1. Cutting Plate Lifting group

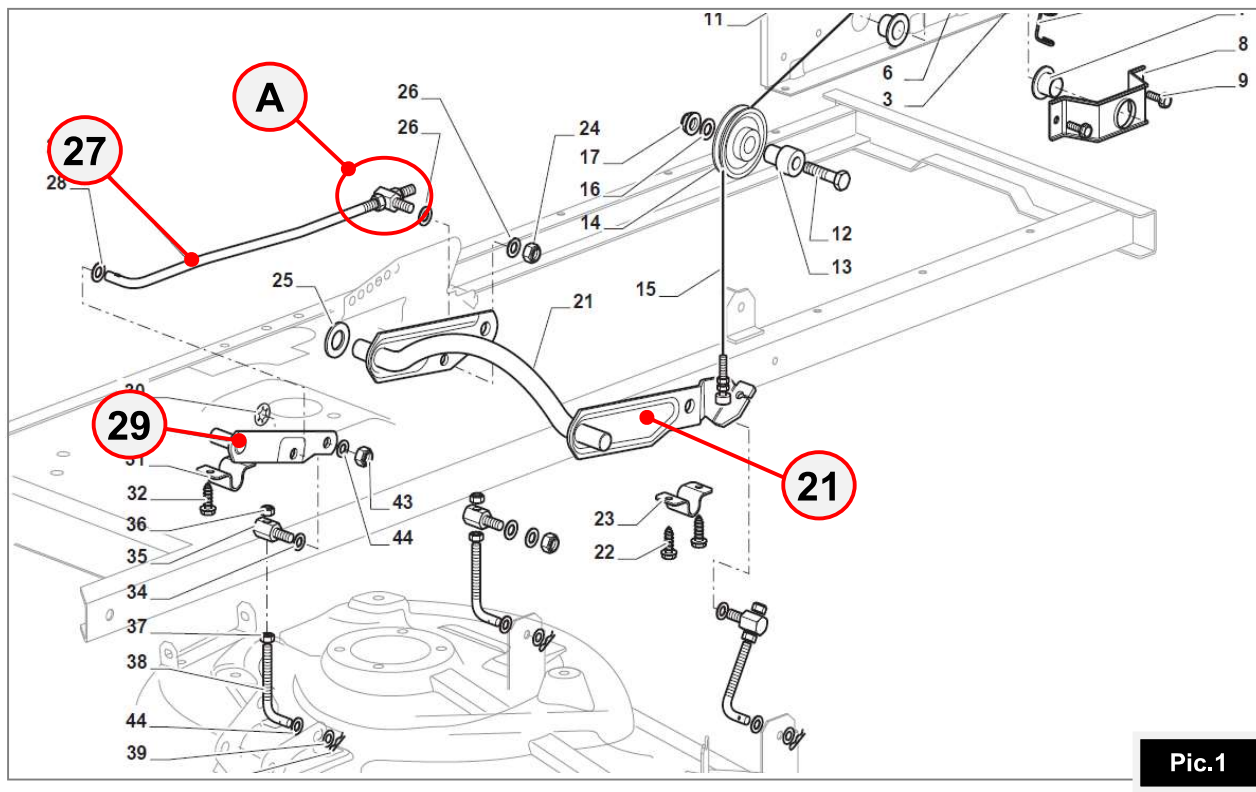
During the season 2014/2015 some claims have arisen from the market concerning the breakage of axle for cutting deck lifting (**Pic.1, part 21**).

1.a – Connecting rod between lever and axle for cutting deck lifting (**Pic.2, part 27**)

The rod diameter of the rod has been increased from 6.8 to 9 mm and the adjustment pin removed (**Pic.1, part A**) since the adjustment of longitudinal position of the cutting deck has never been necessary. In **Pic. 2** you can see the "new" connection between the front lever and rear lifting axle.
